24 February 2009

Submission No 37

SUBMISSION re Draft Disability (Access to Premises – Buildings) Standard

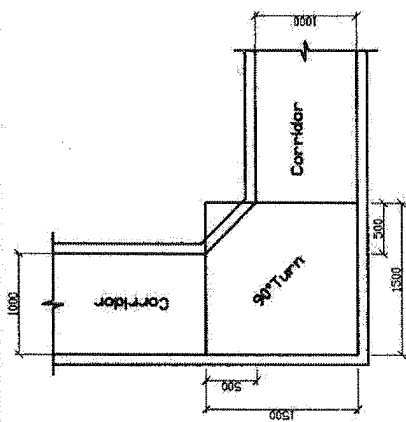
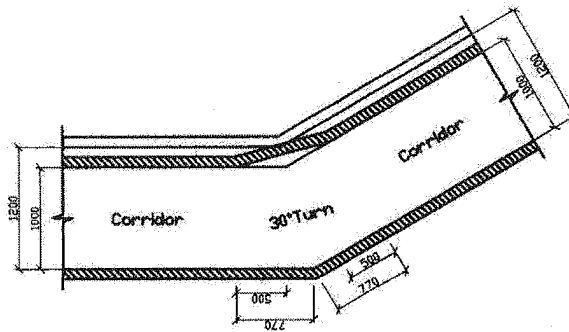
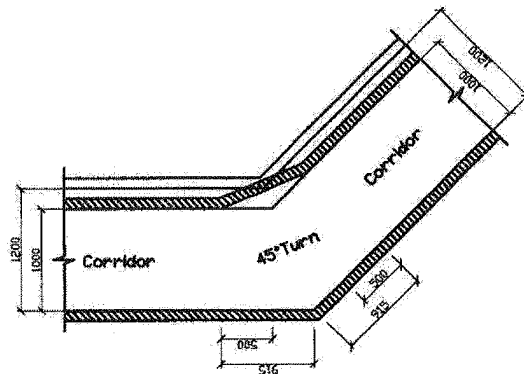
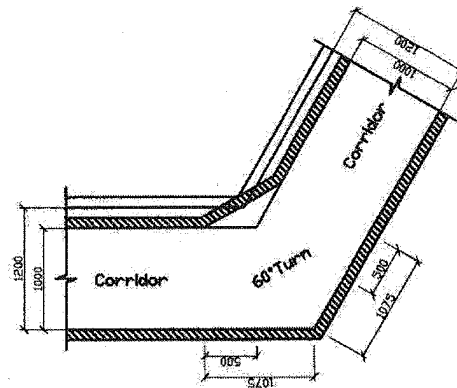
The draft AS1428 part 1 allows for 1000mm wide passageways, with some consideration of "cutting the corner" with some bends. As the attached drawing shows, both of these provisions are inadequate for people who use a standard "A90" wheelchair.

1. Amend AS1428.1 to require a minimum of 1200mm wide passageways

FIGURE 4: REDUCED ACCESS RESULTING FROM INTERFACING CORRIDOR WIDTH FROM AS1428 PART 1-2001 WITH DOOR CIRCULATION SPACE TO AS1428 PART 2-1992

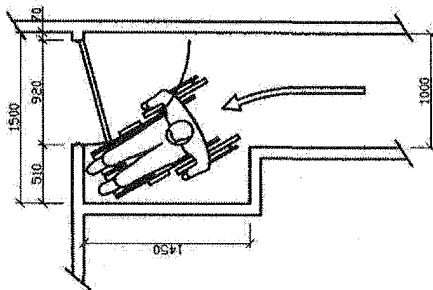
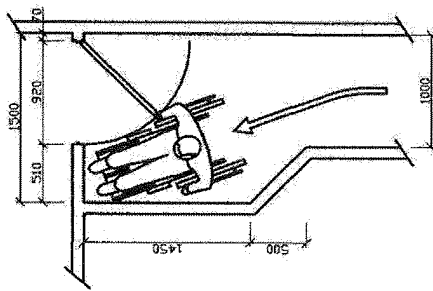
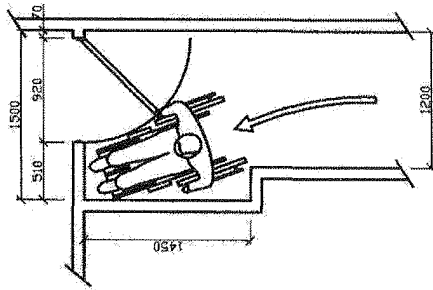
FIGURE 4(a): Proposed Access to Doorway by Interfacing Corridor Width from AS1428 Part 1-2001 with Door Circulation Space from AS1428 Part 2-1992. This layout would not be accessible to many wheelchair users and would waste the additional space.

FIGURE 4(b): Corrected Requirement Suggested for AS1428 Part 1-2001. This layout would be expensive to construct and would encroach further on the adjoining room space.

FIGURE 4(c): Access to Doorway by Providing Corridor Width and Door Circulation Space from AS1428 Part 2-1992. This layout would be inexpensive to construct and would encroach little on the adjoining room space.

FIGURE 2:
Minimum width of Corridor
AS1428.1-2001

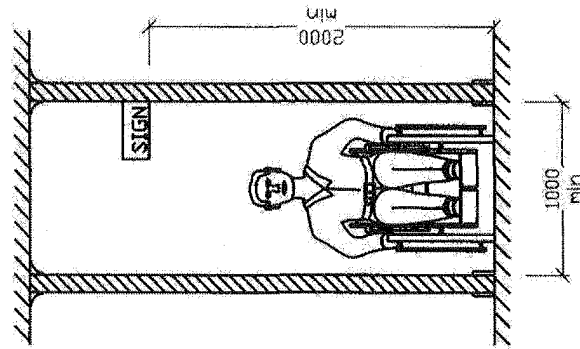
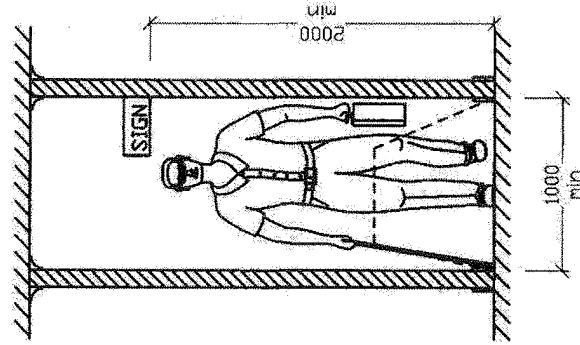
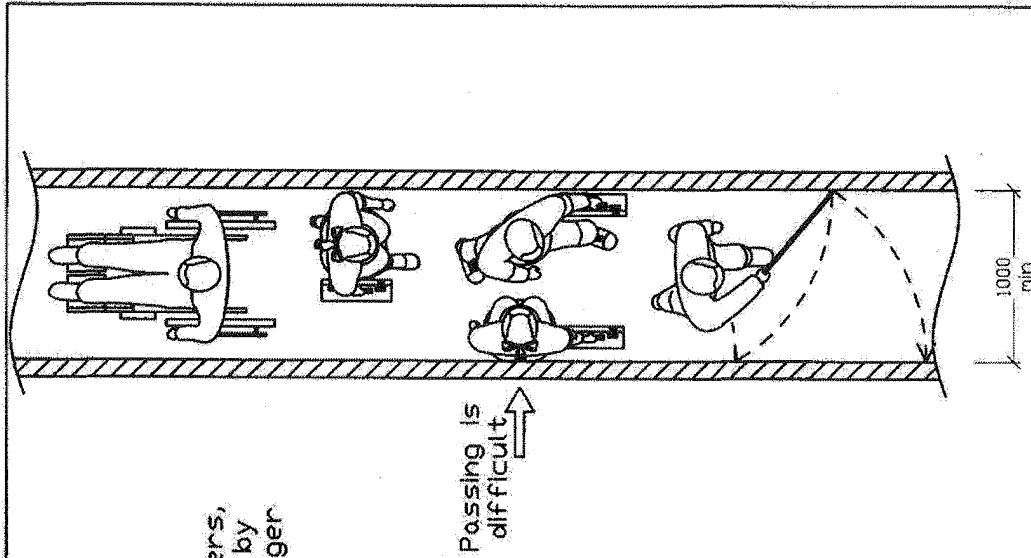
While a 1000 wide corridor may be accessible by most users, it clearly does not permit passing of wheelchair users by ambulant persons. Further, it creates difficulty for larger ambulant persons to pass each other.

FIGURE 1:
Minimum width of Corridor
AS1428.2-1992

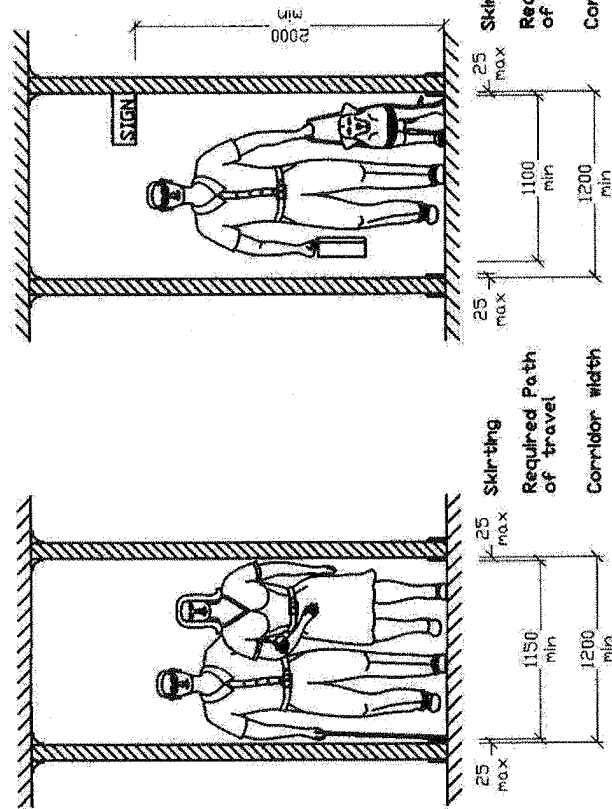
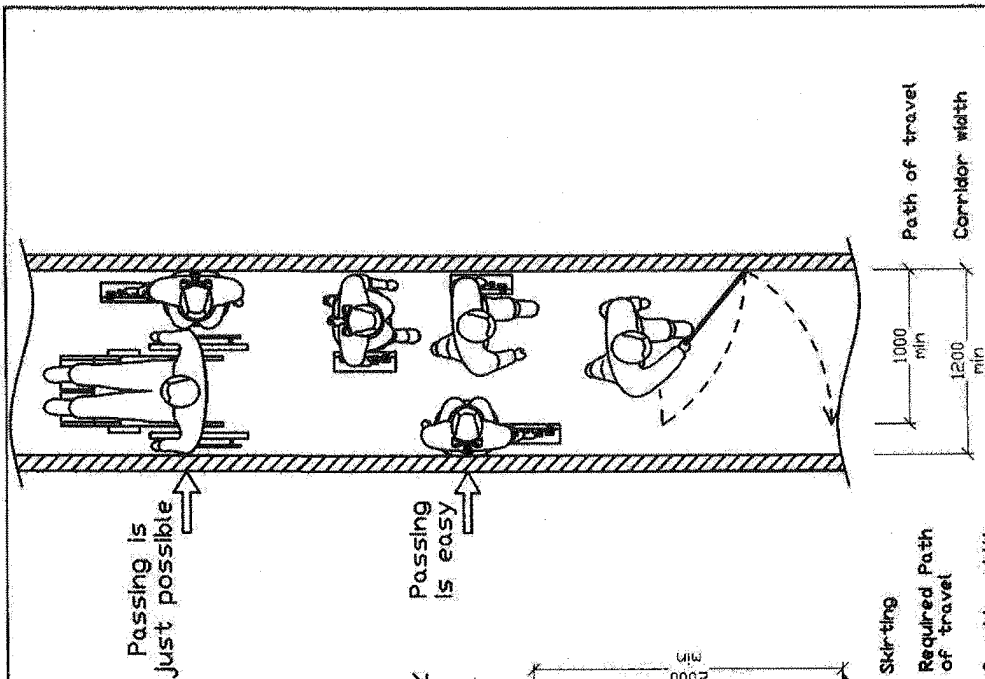
A 1200 wide corridor will be accessible to all users. Although it will permit larger ambulant persons to pass each other with ease, it is still difficult for an ambulant person and wheelchair user to pass.
